# ADDITION TO PUBLIC WORKS SERVICE CENTER TOWN OF ADDISON TEXAS

**TOWN OF ADDISON**  
**BUILDER'S COPY OF PLANS**  
 This set of plans contains various corrections and comments made by the City Staff. All trades will be required to comply with these corrections and comments; failure to inform all trades of this information will not be accepted as a reason to approve construction which is in violation of local ordinances.  
 This set of plans is to be kept on the job site at all times and is to be made available for use by city inspectors at their request. Failure to have these plans available may delay approval of a requested inspection.

**ADDITION TO PUBLIC WORKS SERVICE CENTER**  
 Westgrove Road  
 Addison Texas

01 FIRST FLOOR PLAN  
 A2.1 1/8" = 1'-0"

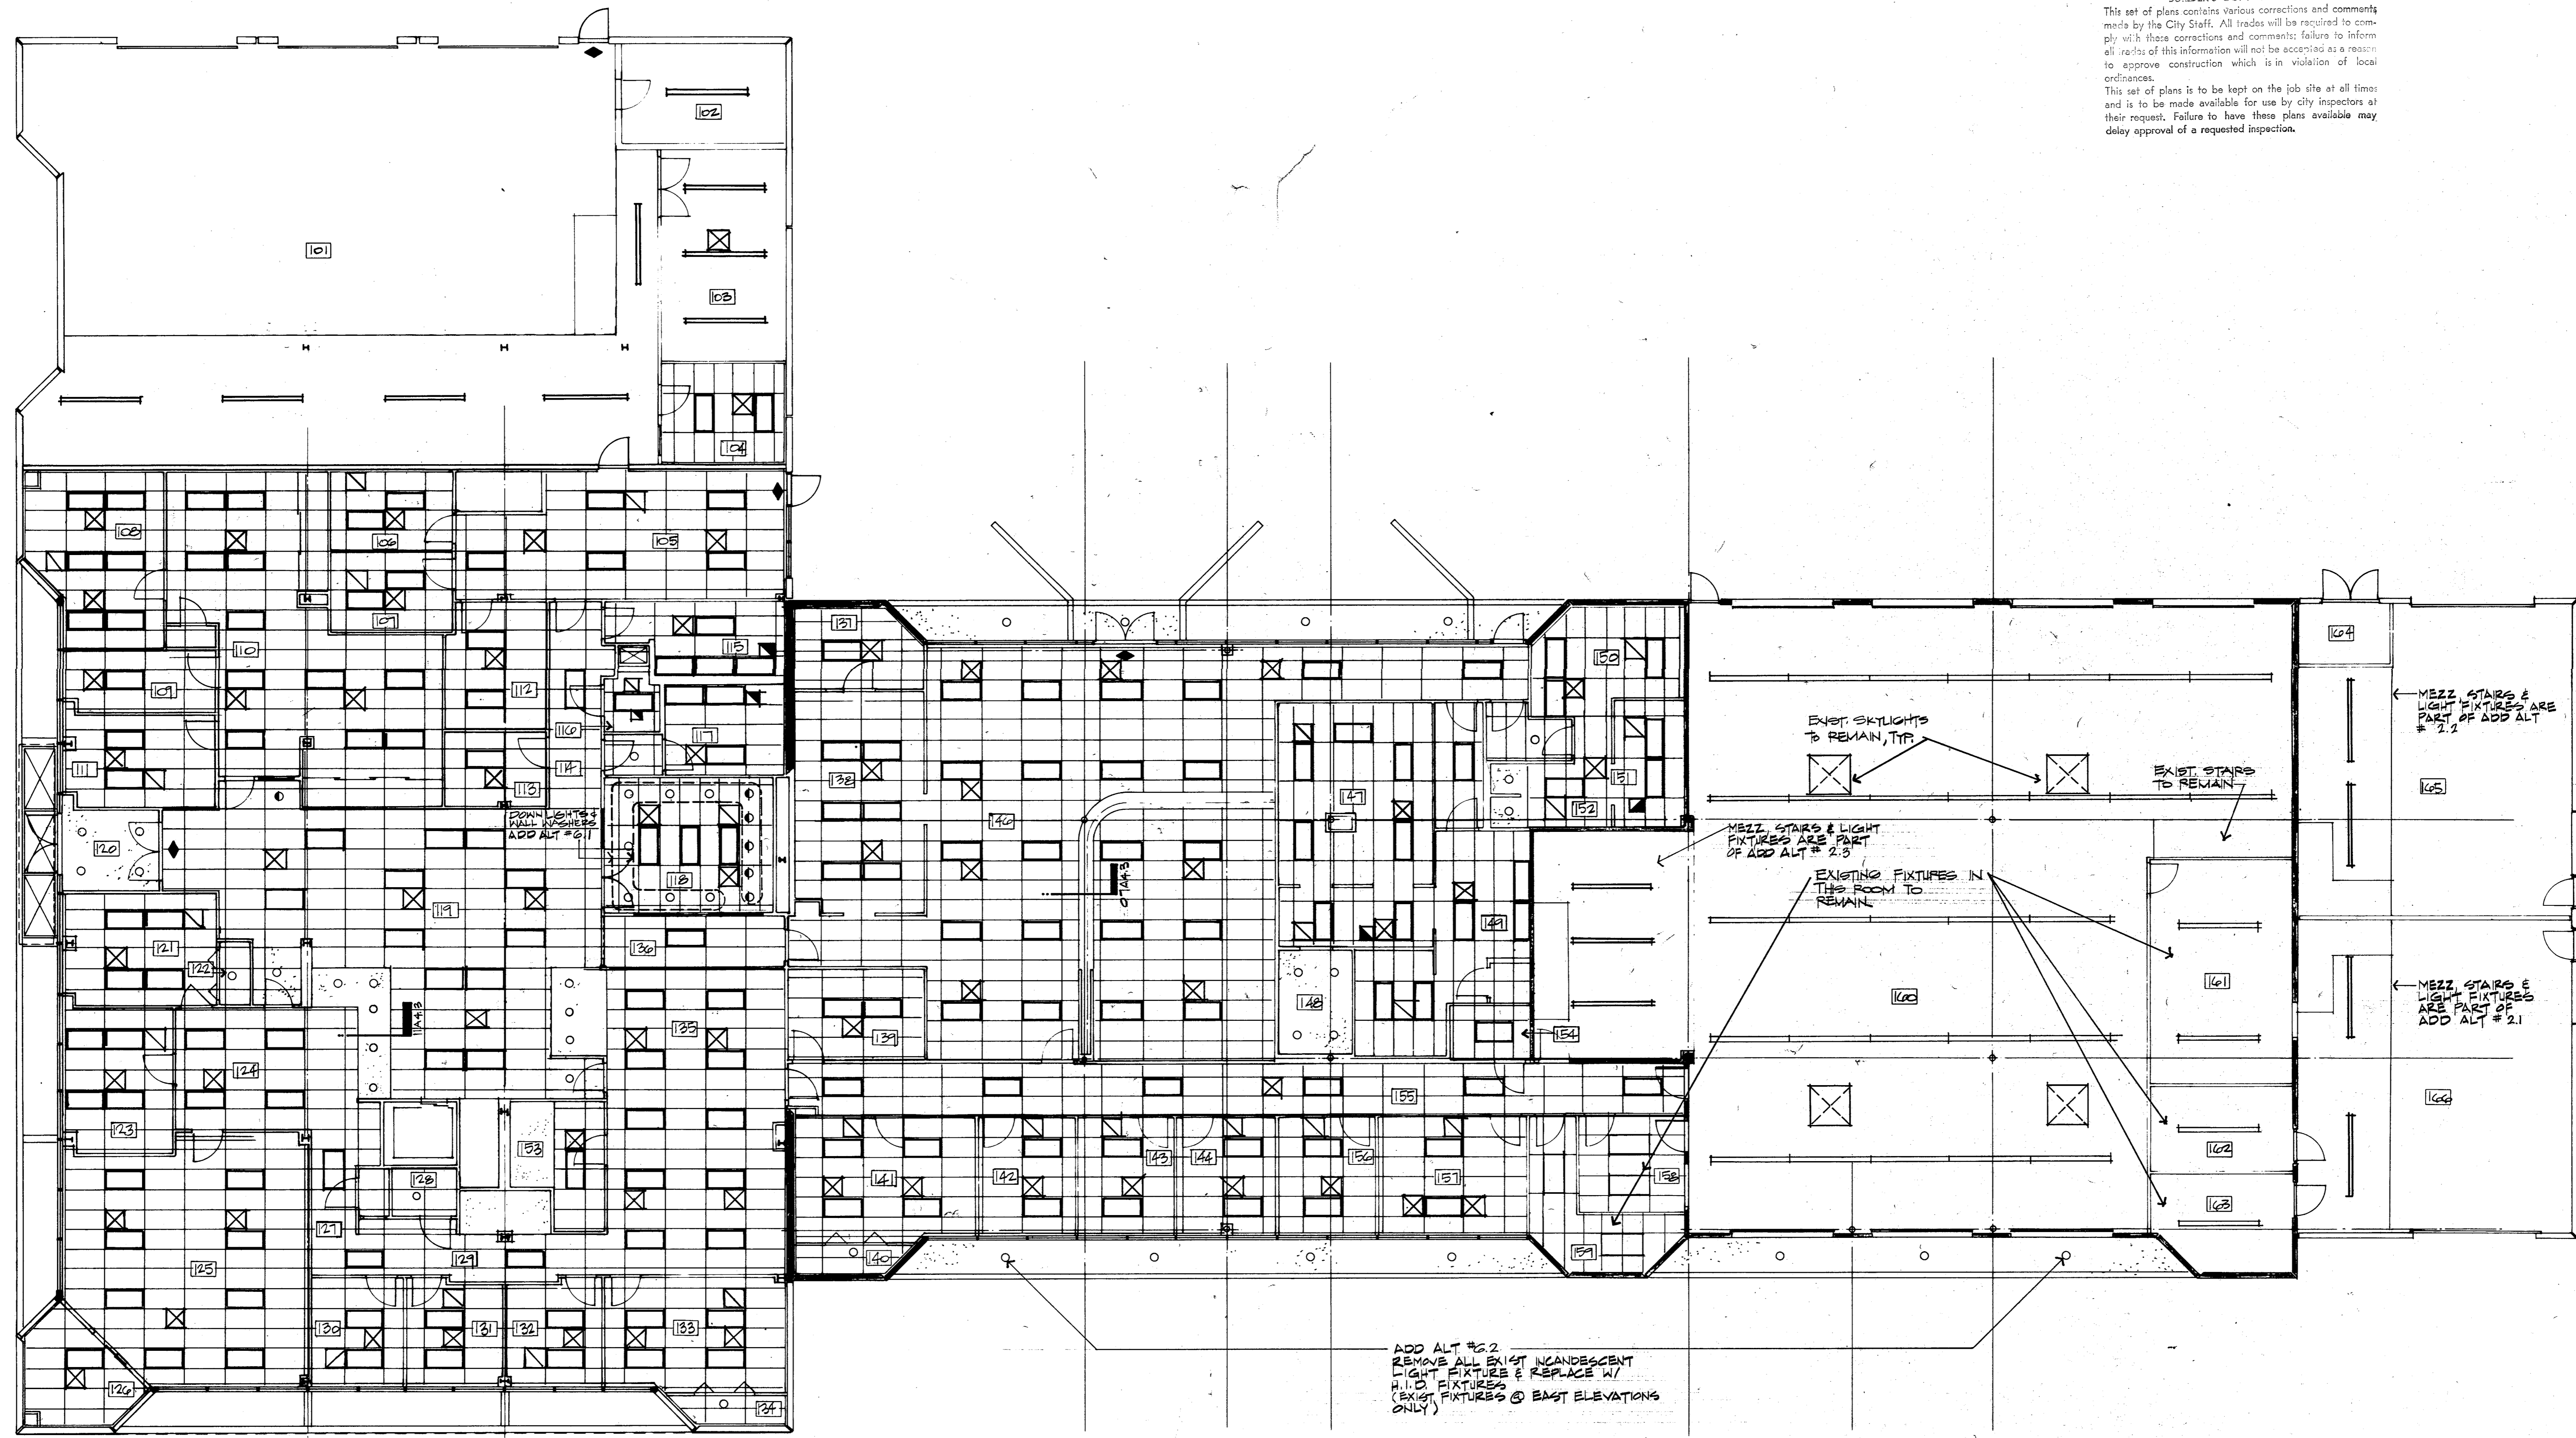
1. 1HR. OR 2 HR. RATED WALLS TO DECK OR TO CEILING IF 1HR. OR 2HR. ASSEMBLY USED. ~~REMOVE THIS WALL~~
2. ALL FIRE RATED DOORS MUST BE SELF-CLOSING W/ CASSETS.
3. Five extinguishers:  
 Minimum 2A 10BC  
 Minimum of 1 per 3000<sup>sq</sup>  
 Maximum travel distance of 75' to any extinguisher

**01**  
**E2.2**  
**FIRST FLOOR PLAN- LIGHTING**

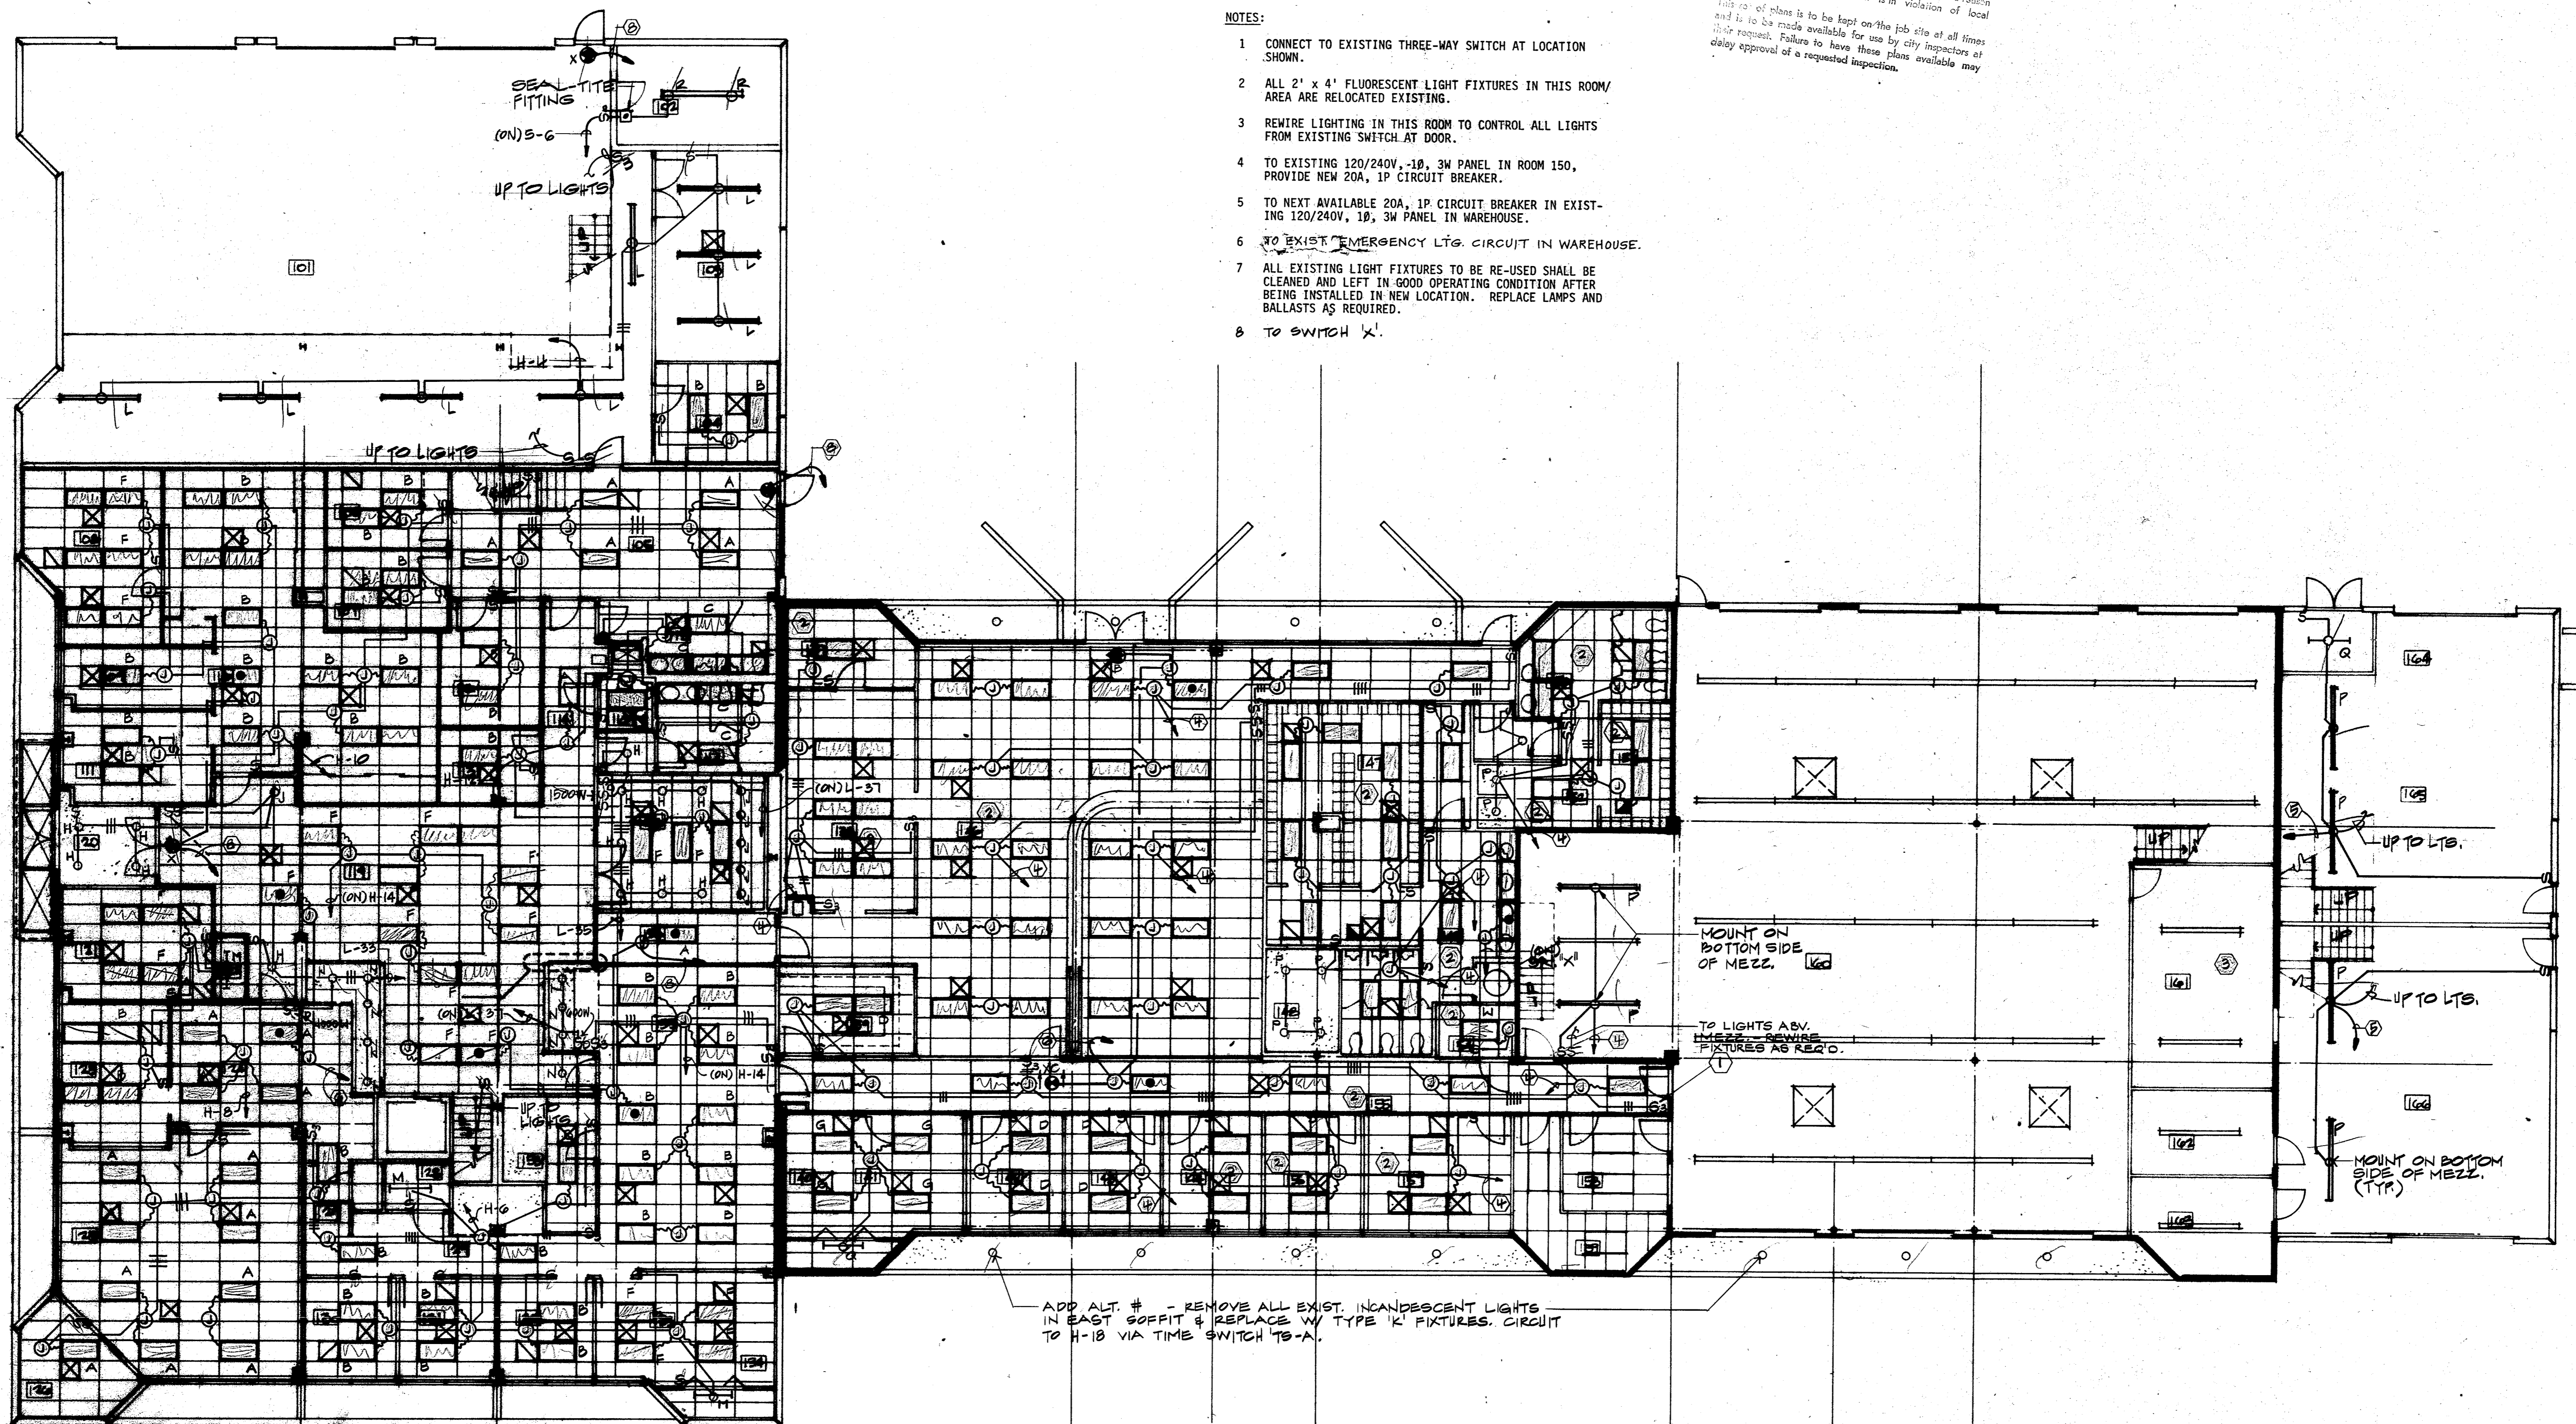
ADD ALT # - REMOVE ALL EXIST. INCANDESCENT LIGHTS IN EAST SOFFIT & REPLACE W/ TYPE 'K' FIXTURES. CIRCUIT TO H-18 VIA TIME SWITCH TO-A.

01 FIRST FLOOR PLAN - PLUMBING  
 P2.1

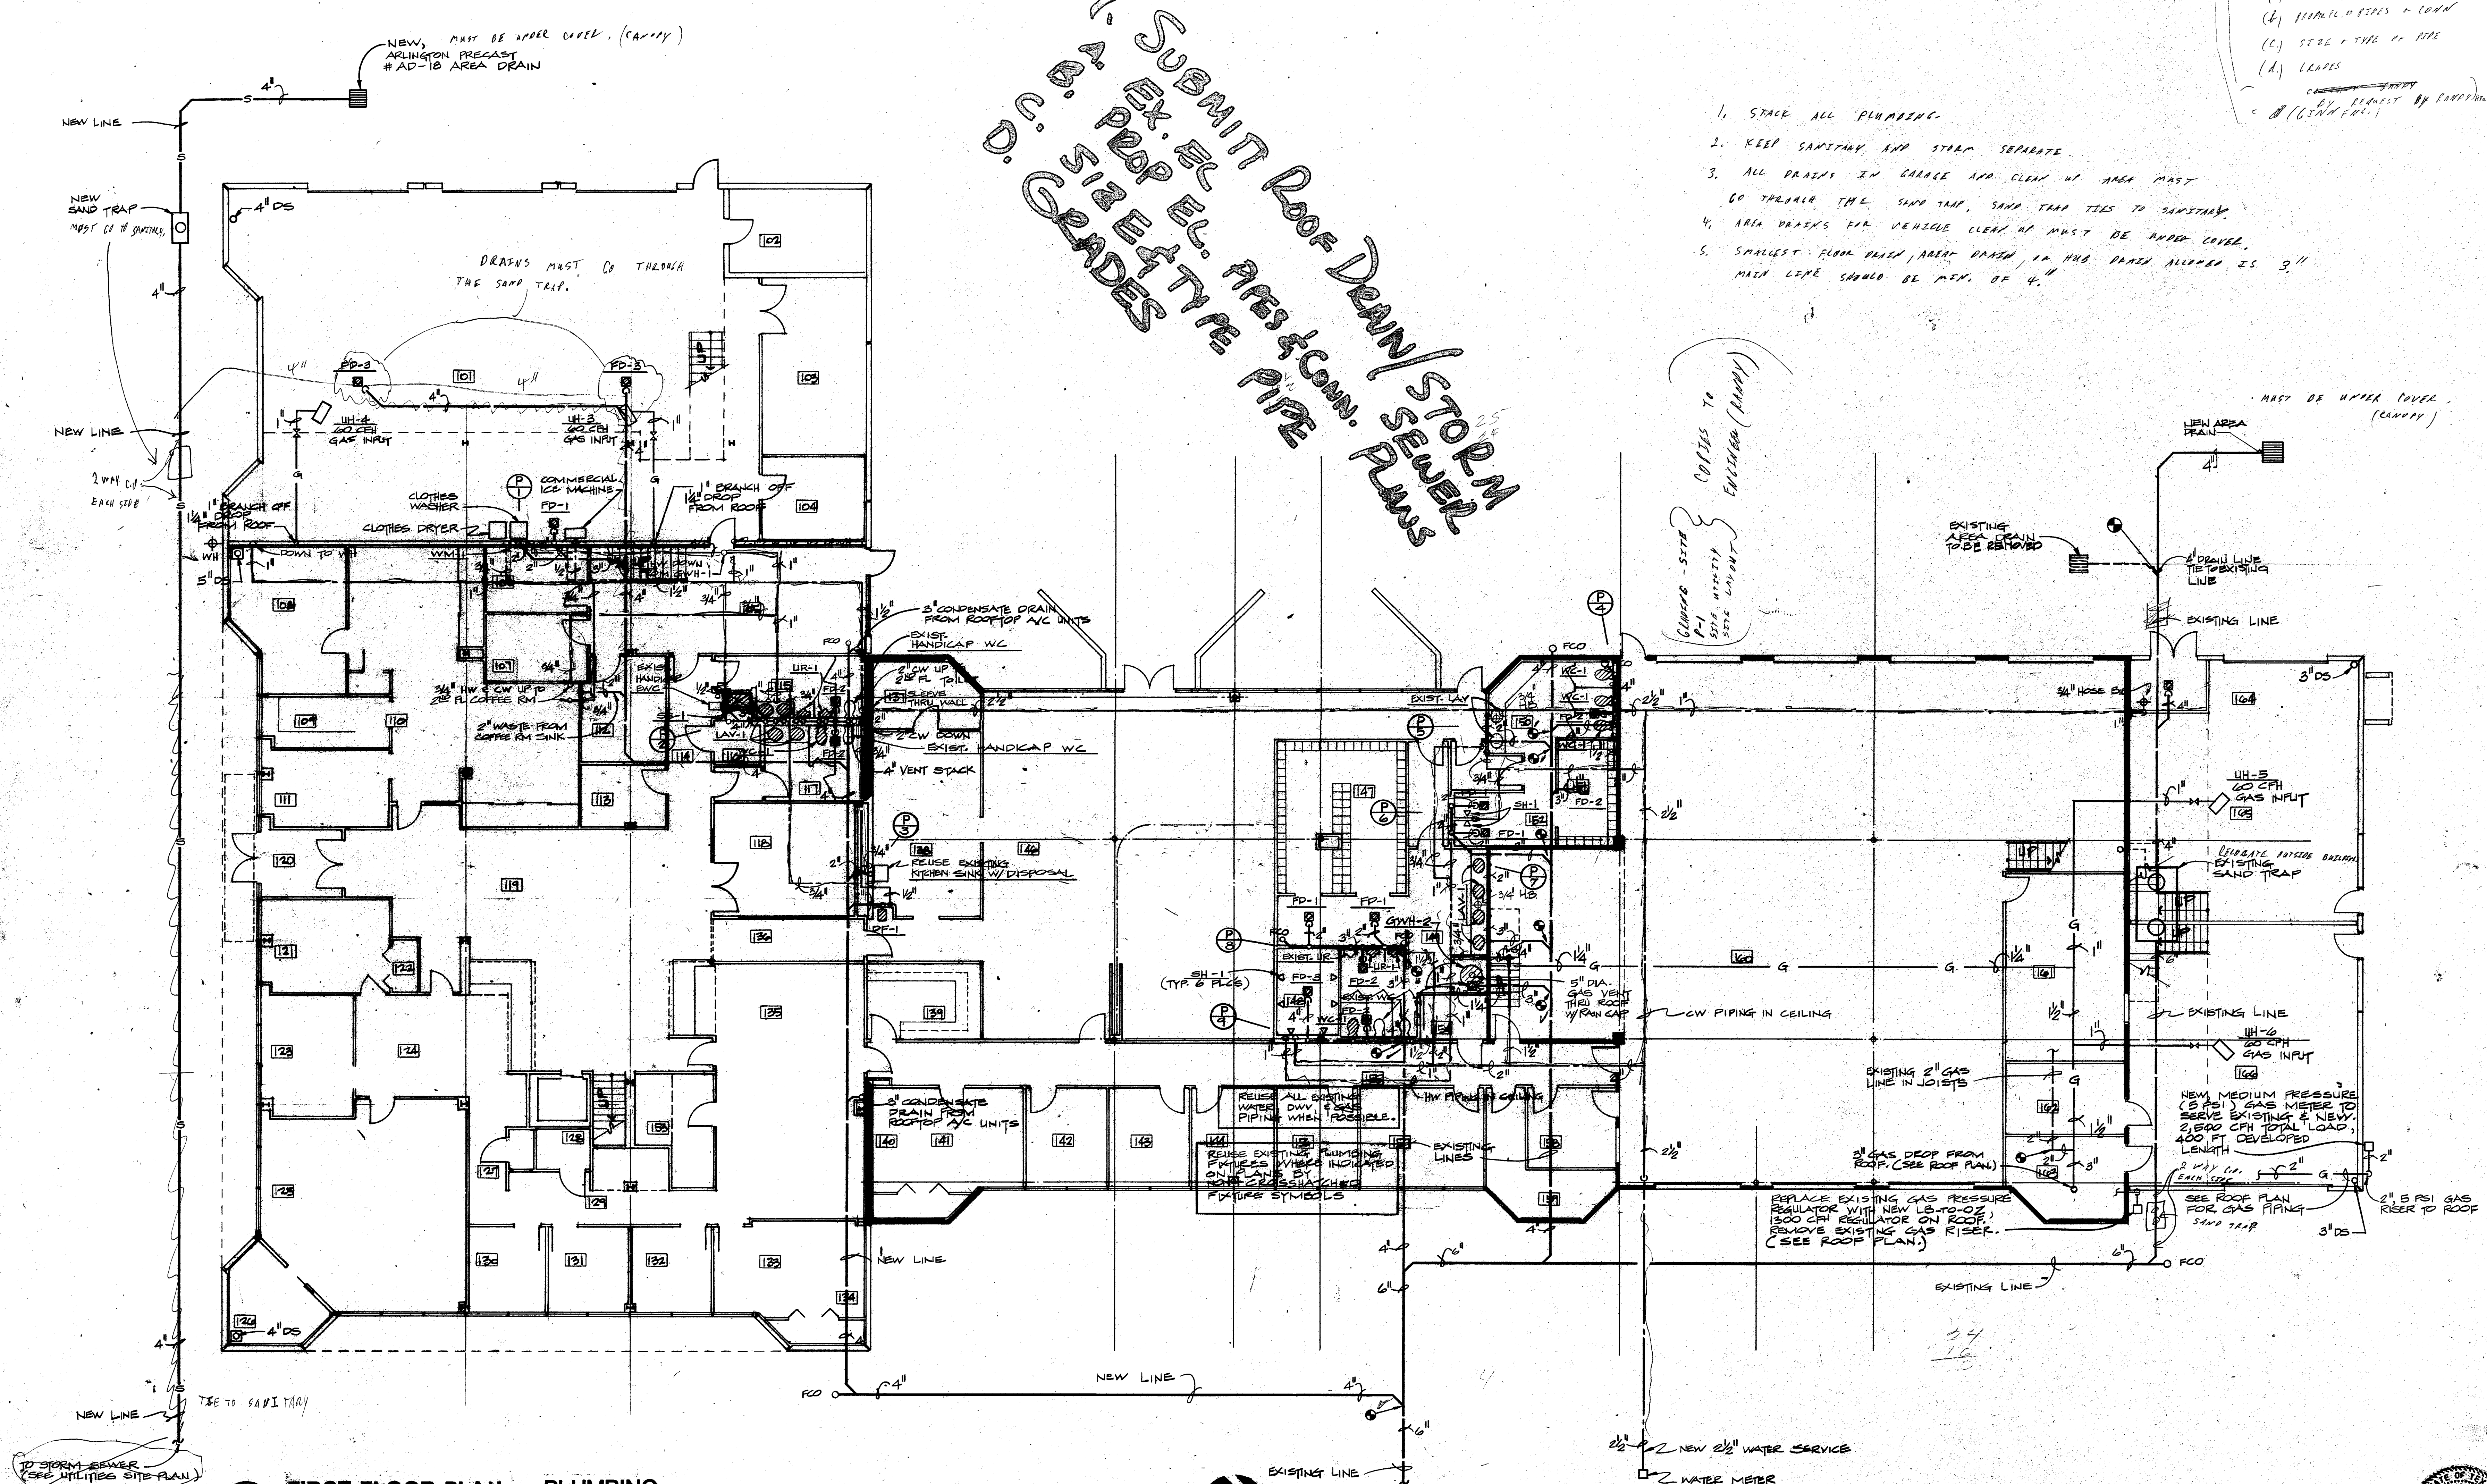
PLUMBS ISSUED IN FOLLOWING COLUMNS:  
 NO UTILITIES TO BE  
 INSTALLED UNTIL THE  
 FOLLOWING PLANS ARE SUBMITTED  
 AND APPROVED BY ENGINEER  
 AND UTILITY COMPANIES:  
 1. CAVITY SITE PANS  
 2. P-1 (REVISED PLUMBING PANS)  
 3. SITE UTILITY PANS  
 4. SITE LAYOUT PANS

INFORMATION NEEDED:  
 A. SITE DATA, STAIR, AND SERVICE  
 B) EX. ELECTRICAL  
 C) MECHANICAL SYSTEMS + LOADS  
 D) SITE + TYP. OF FLOOR  
 E) LOADS  
 BY REQUEST BY CONTRACTOR  
 (SEE PLAN)

**1. SUBMIT ROOF DRAIN/STORM SEWER PLANS**  
 D.C. OR A.P.E. EX. EL. PIPES & CONN. PIPES  
 5/12 EAT TYPE PIPE GRADES
